5.2 MAJOR TOPICS RESPONSES

5.2.1 MR-1: Selection of Alternatives

5.2-2 MR-2: Operational Noise Analysis Methodology and Impact Thresholds

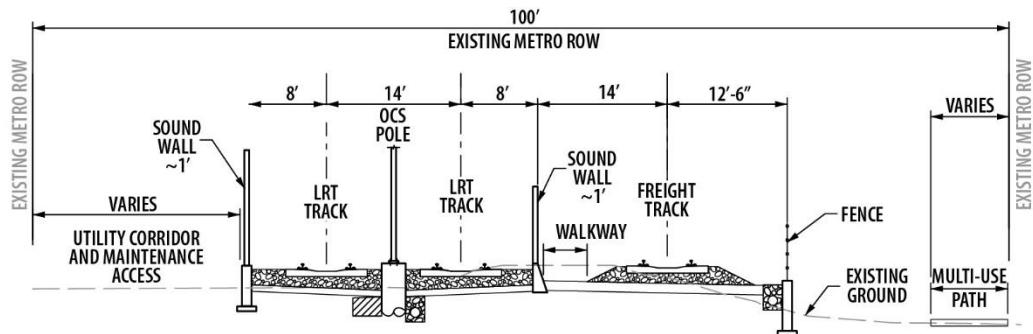
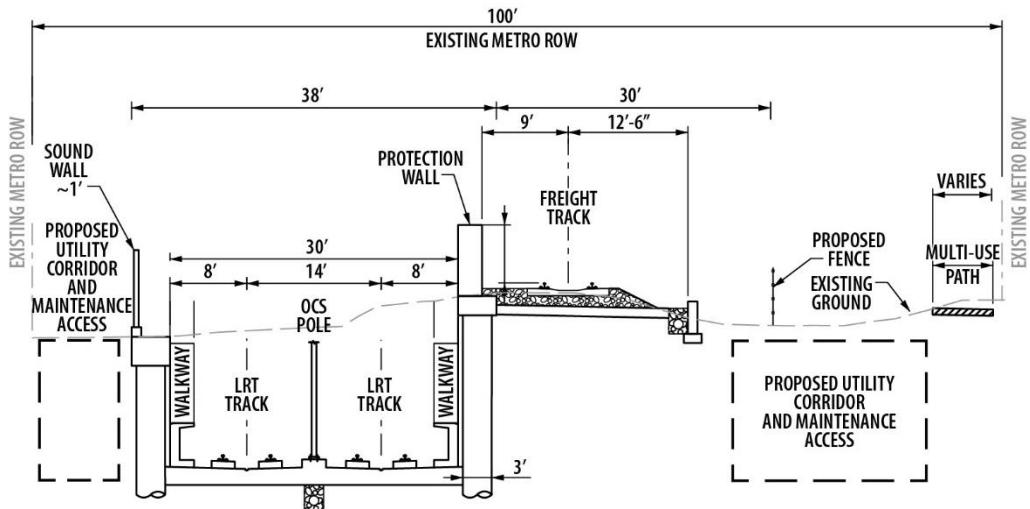
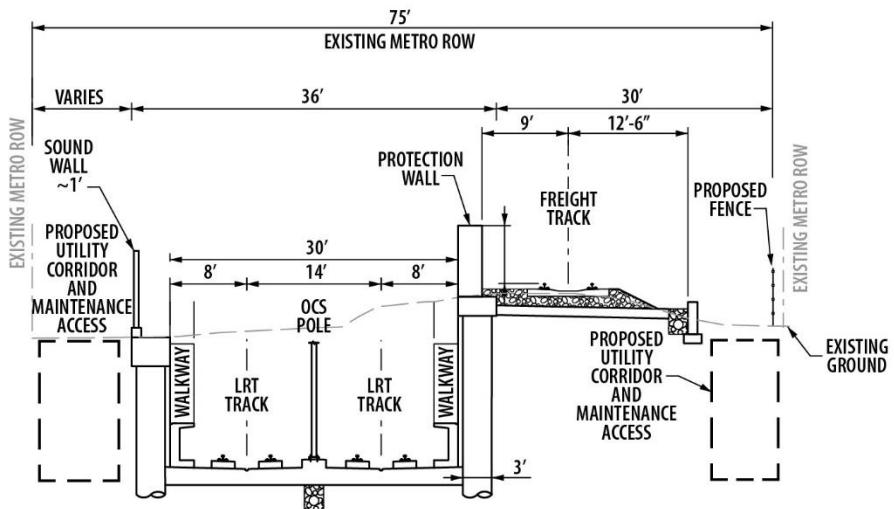
Some commenters expressed concern about rail safety in and around the Metro ROW, particularly regarding increasing the number of trains in the corridor, the potential for freight train derailment, and the risk of accidental release of hazardous materials being transported by freight. They also questioned whether the Metro ROW is wide enough to safely accommodate two new light rail tracks and a freight track. Engineering analyses confirm that, with design tailored to the corridor's constraints and conditions, including limited widening in certain locations, the Metro ROW can be configured to safely accommodate both light rail and freight operations. Metro is committed to enhancing safety throughout the corridor and would implement infrastructure improvements and operational protocols in compliance with applicable federal, state, and local safety standards. As described below, the project has been, and would be, designed to meet established regulatory standards, safety protocols, and structural requirements to ensure the safe coexistence of light rail and freight operations within the Metro ROW.

In the residential areas of Lawndale and Redondo Beach, the Metro ROW is generally about 100 feet wide, with some exceptions. It is narrowest between 170th Street and Artesia Avenue, where it is 75 feet wide, and just south of 182nd Street, where it is between 83 and 84 feet wide. Metro conducted a property survey in Spring 2025 to verify Metro's property boundaries, as reflected in the Final EIR, Appendix B, Select Advanced Conceptual Engineering Drawings - Locally Preferred Alternative. Throughout the entire corridor, the Metro ROW is sufficiently wide to accommodate project elements safely, including tracks, retaining walls, and soundwalls. Safety spacing informed by requirements established by Metro, BNSF, and CPUC have been and would be incorporated into the project design to ensure safe operations. These include:

The representative cross-sections below (Figure 5.2-2, Figure 5.2-3, and Figure 5.2-4) show examples of how the light rail and freight guideways, along with other elements such as retaining walls, soundwalls, maintenance walkways, utility corridors, and a multi-use path, fit safely within the available ROW. Even with all these additional elements, there is sufficient space to accommodate both the project and freight operations safely.

The project's design is informed by FRA and Metro standards and criteria for parallel track operations, including appropriate track spacing to ensure an adequate and safe distance between freight and light rail along the corridor. Tracks would be spaced to minimize the potential for any interference between the freight and light rail operations, allow sufficient room for the installation of safety barriers, and provide buffer zones to help contain any unlikely incidents, such as a minor derailment within the Metro ROW. The spacing would take into account train speeds, freight types, and site-specific conditions.
